BCA REPORT

Schematic Design Stage

Hunter River High School

Schools Infrastructure

Figure 6: Block Y

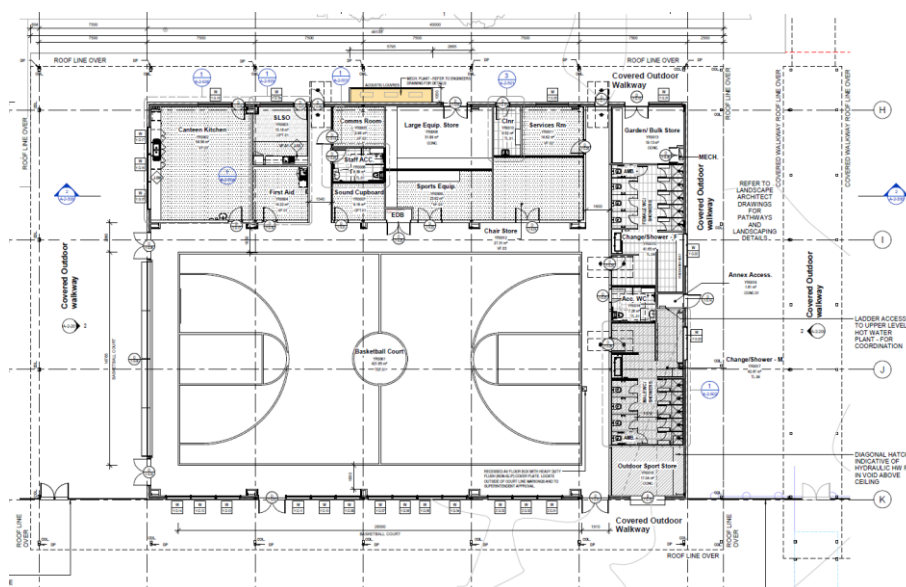
Particular attention will need to be paid to Block Y where deemed Type B construction and having loadbearing walls as it is within 18m of adjoining fire source features. We note that the building has been deemed Type C based on the first-floor area not being deemed a storey under C1.2 of the BCA. Where a use other than a plant room is proposed the Type of construction would need to be re-assessed accordingly architect to monitor for compliance in this regard.

Figure 12: Typical Example of Proposed Equipment

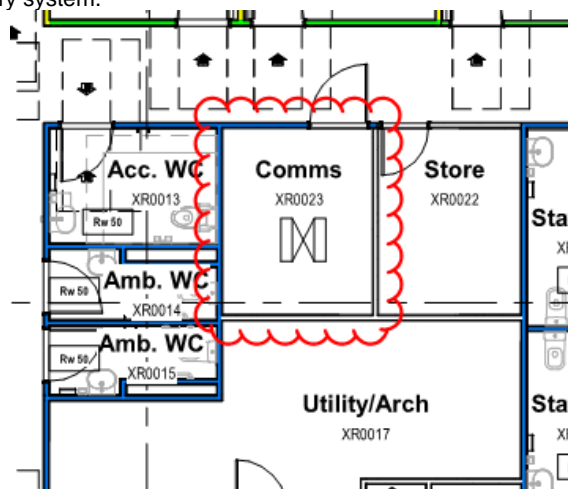
Services consultants will need to review and advise of any proposed equipment within the building requiring separation under this clause. We note that there are a number of comms rooms proposed

however it is not clear whether there is equipment proposed within these rooms which would require separation i.e. battery system.

The type of equipment proposed and any required fire separation where required will need to be shown on the DD documentation.

Figure 13: Block R Type of Construction

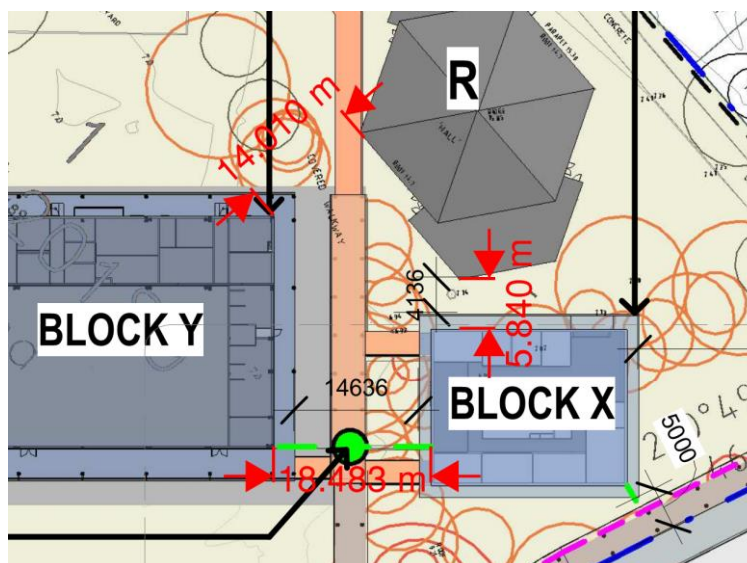
As Block R is of Type B construction, structural engineer is to confirm whether the external walls are loadbearing and whether required to be fire rated under this clause. It will then be determined if any upgrade works are required. Should it be necessary there is potential scope to address the exposure between buildings under a Fire Engineered strategy.

Figure 22: Covered Walkway Adjacent to Public Road Access

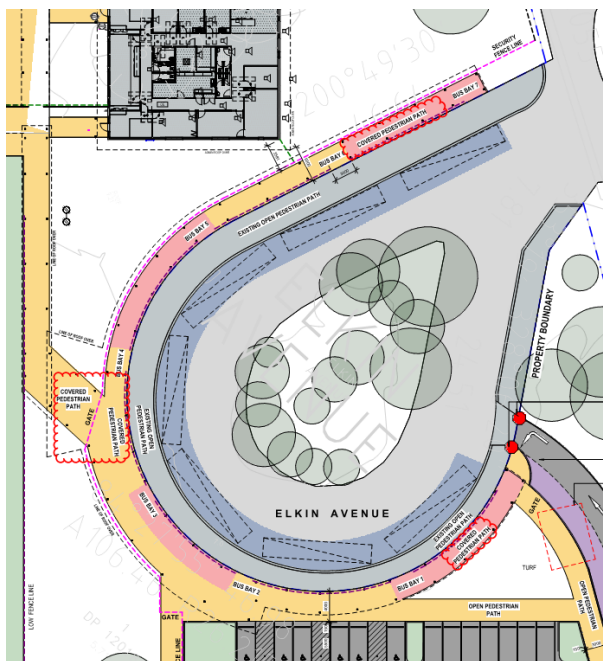
The discharge from the required exits to the road is to be confirmed based on the positioning the proposed buildings and works it is likely that the occupants will need to pass back under the covered walkways and awnings.

Based on the location of covered pedestrian walkways and internal fencing in the architectural site plan it is likely that a fire engineered performance solution will be required to address the proposed egress strategy.

Figure 23: Ladder Access to Gymnasium Mechanical Annex

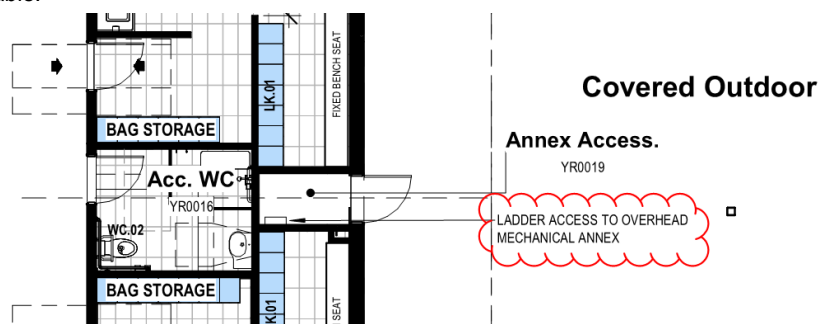
Based on updated architectural documentation, ladder access is proposed to the gymnasium mechanical annex. Given the annex space serves only plant equipment, compliance is readily achievable.

Figure 24: Doors Swing against the Direction of Egress

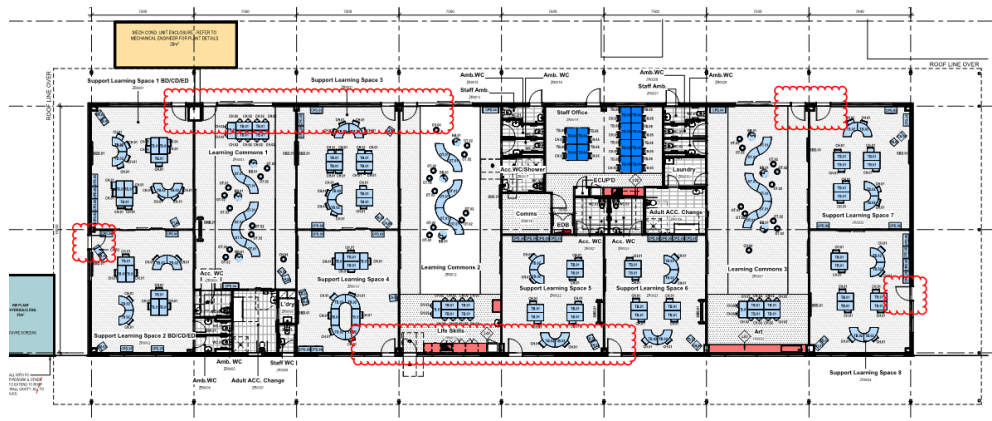
Within the current design, there are several doors currently shown to swing against the direction of egress in a case where required to swing in the direction of egress. These doors are to be re-swung and or the arrangement is to be addressed by way of a Fire Engineered Strategy.

Figure 25: Proposed Internal and Boundary Gates

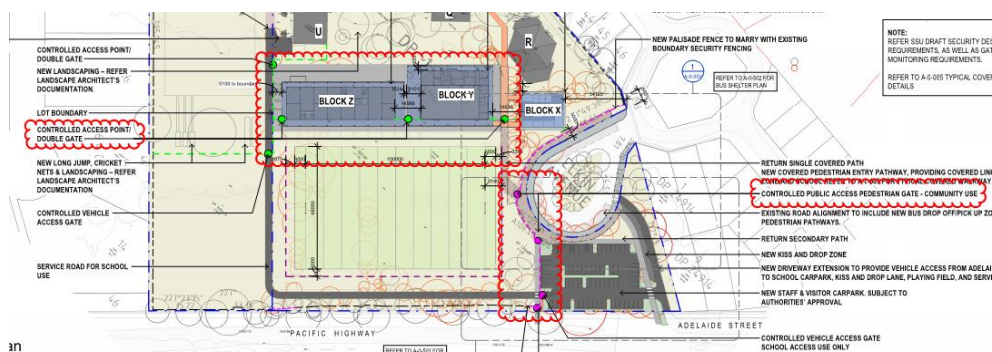
Any proposed lockable gates or the like located in the path of travel and or permitter gate (D1.10).

Figure 26: Gymnasium - Roller Door

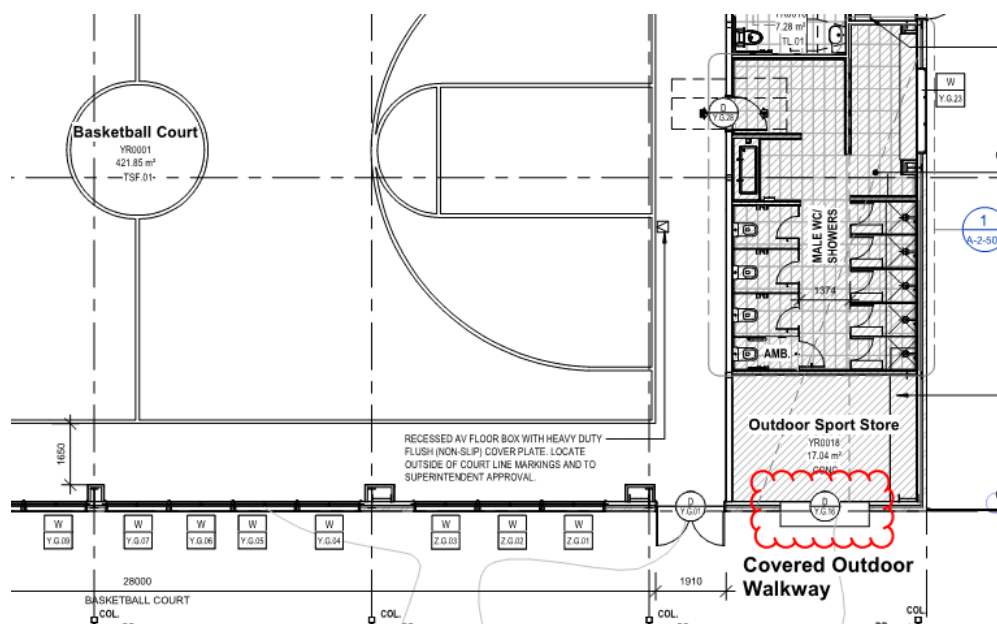
Roller shutters in the outdoor sports storeroom, as outlined in the figure below, are to be addressed by way of a fire engineered solution.

Figure 28: FHR Coverage Required

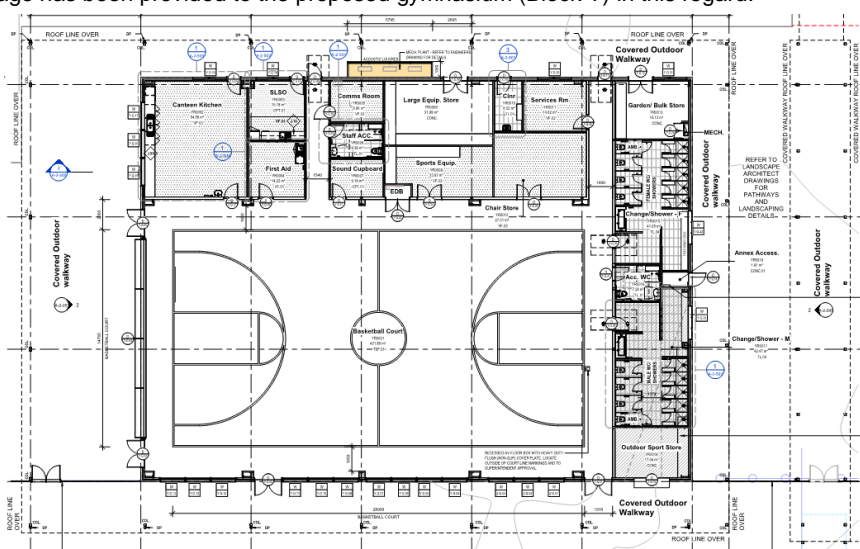
Hydraulic consultant will need to provide coverage mark-ups demonstrating that compliant FHR coverage has been provided to the proposed gymnasium (Block Y) in this regard.

Figure 29: Mechanical Plant Proposed in front of Classroom Window

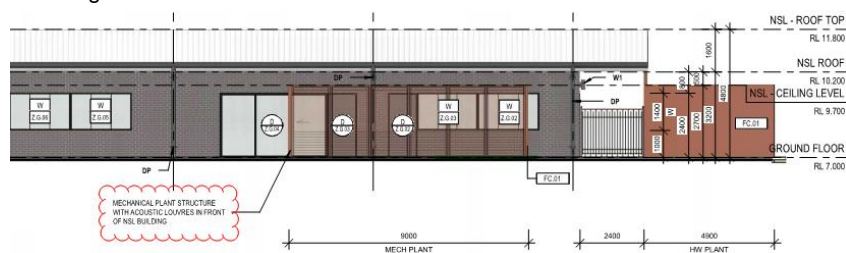
Details are to be provided confirming Support Learning Space 1 and Learning Commons 1 of the NSL building achieved adequate natural light given the location of mechanical plant adjacent to the northern façade. Architect to review and ensure compliance details to be provided along with the DD phase in this regard.

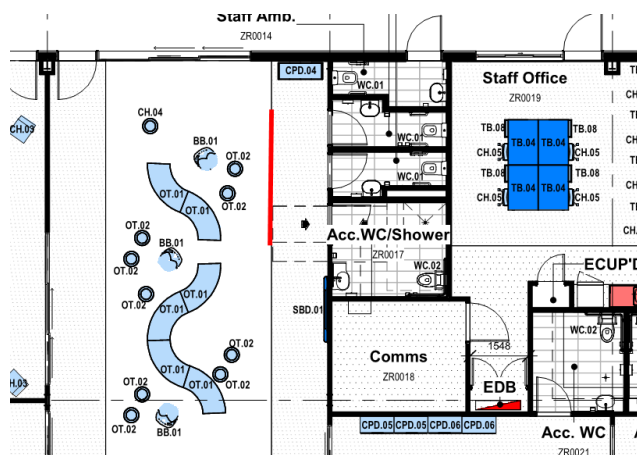
Currently the sanitary compartments open directly up into learning commons particularly areas used for assembly based on the location of the adjoining seating. In this regard, either a hallway or a screen and local exhaust is to be provided to the sanitary compartments (typical example below)

Where the space necessitates direct access of the learning space or support learning areas then the extent of separation is to be addressed by way of a Performance Solution.
